AGENDA
CHARTER TOWNSHIP OF MERIDIAN
PLANNING COMMISSION – REGULAR MEETING
August 26, 2019 7PM

To: Planning Commission

**Special Use Permit #19111 (Woodward Limited Dividend Housing Association)
Planning Commission (August 26, 2019)
Page 2**

SITE PLAN OVERVIEW
WOODWARD WAY
SIRHAL & GREENCLIFF DRIVES
MERIDIAN TOWNSHIP, MI

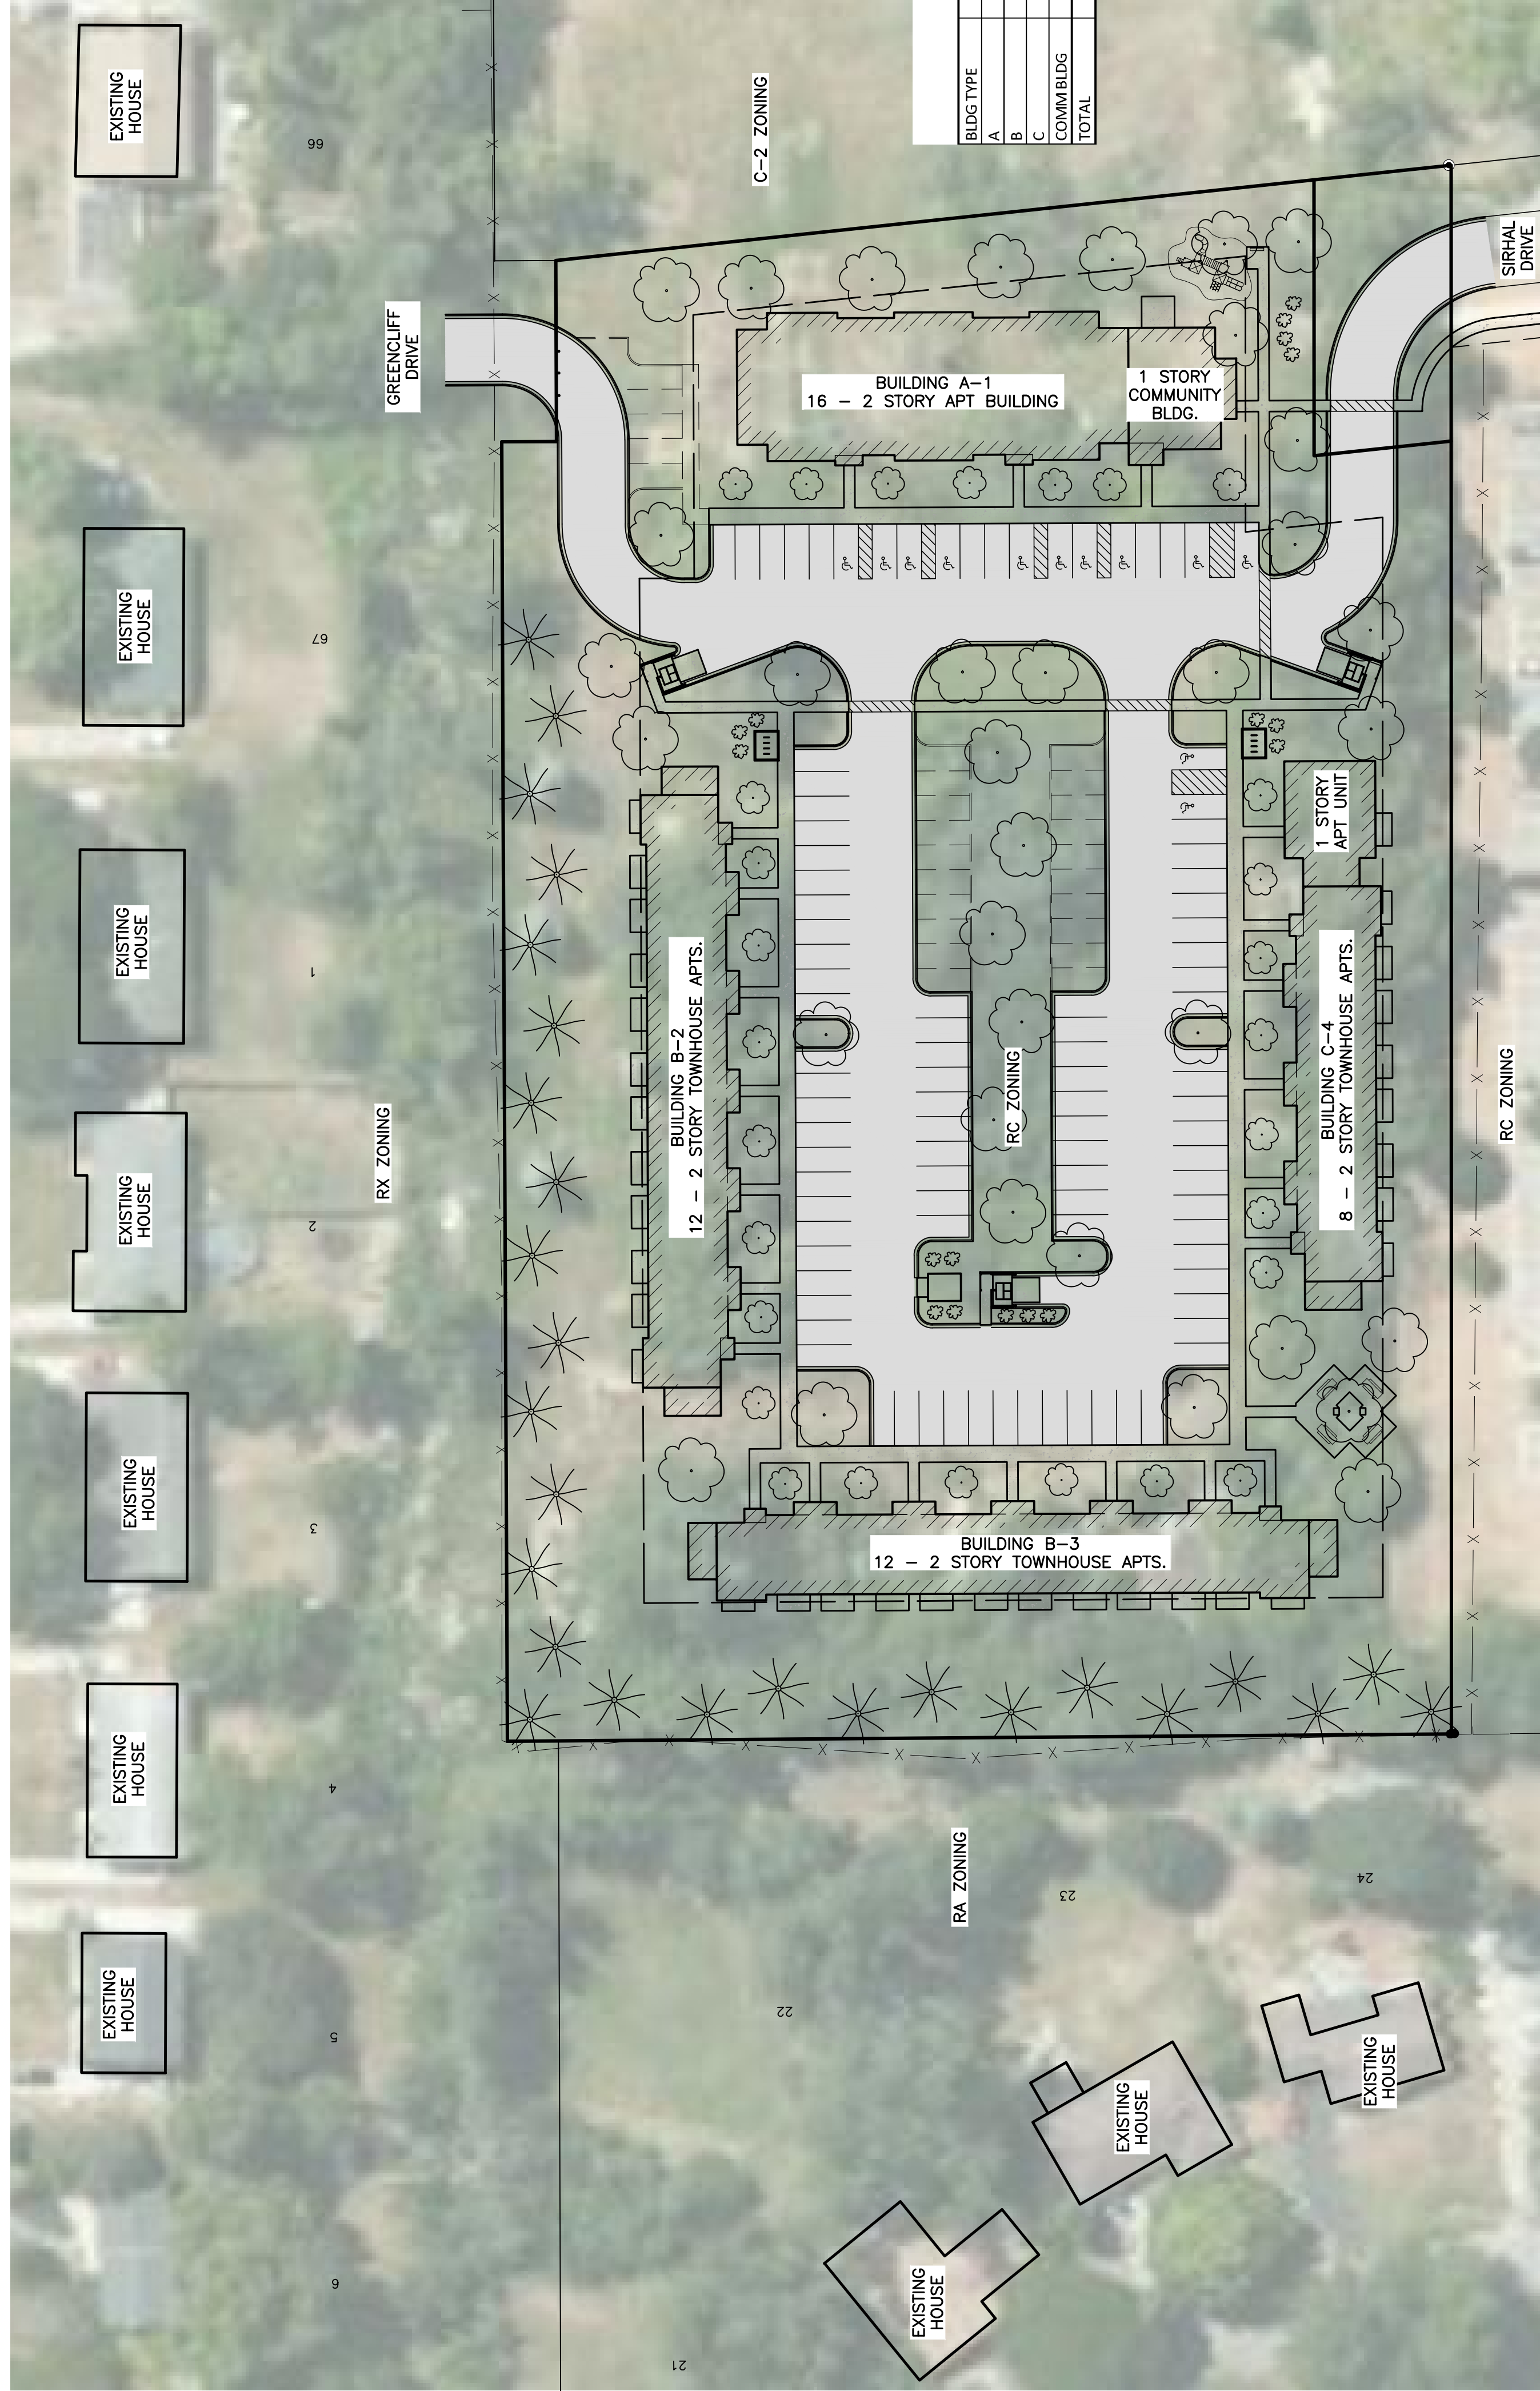
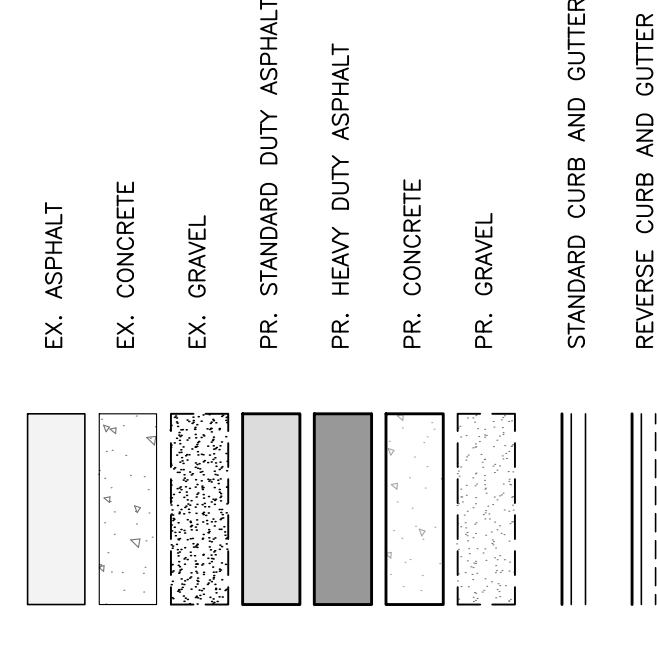
Based on the initial site plan a variance was required for the setback between Buildings B-2 and B-3. With the revised site plan the location and orientation of buildings have shifted to meet all setbacks between buildings, so a variance is not necessary.

No single building or connected building may exceed 200 feet in any one dimension. The revised site plan shows Building C-4 was reduced in length from 205 feet to 200 feet, so the previously identified five foot variance is no longer required. The length of Buildings A-1, B-2, and B-3 remained the same. At 237 feet in length, Buildings B-2 and B-3 require a 37 foot variance for the maximum building dimension. Based on the reduced size of Building C-4 the total size for all buildings in the development decreased from 53,353 square feet to 52,861 square feet in size, a 492 square foot reduction.

Based on the building layout shown on the previous site plans variances would have been required from the 25 foot setback from the entrance of a multiple family structure to a parking area and the 20 foot setback from the wall of a multiple family structure to a parking area. Based on the revised site plan all buildings in the development meet both setbacks, therefore the previously identified variances are no longer required.

With the revised site layout a 20 foot variance from the 40 foot parking setback from the residential zoning district to the east is no longer required.

The original site plan proposed no screening along the north and east property lines. The previous site plan showed a four foot tall landscape earth berm along the north and east property lines. Discussion at the last meeting included challenges of maintaining landscaping planted on a berm. The revised site plan shows a double row of conifer trees along the north and east property lines for screening.

With the revised site plan building coverage is at 15.45 percent and 51.95 percent of the site is open space. The maximum building coverage allowed in the RC (Multiple Family) zoning district is 35 percent and the minimum open space required is 35 percent.

1. Approval is in accordance with the site plan prepared by Monument Engineering Group Associates, Inc. dated August 7, 2019 (Revision Date August 21, 2019) and received by the Township on August 22, 2019.
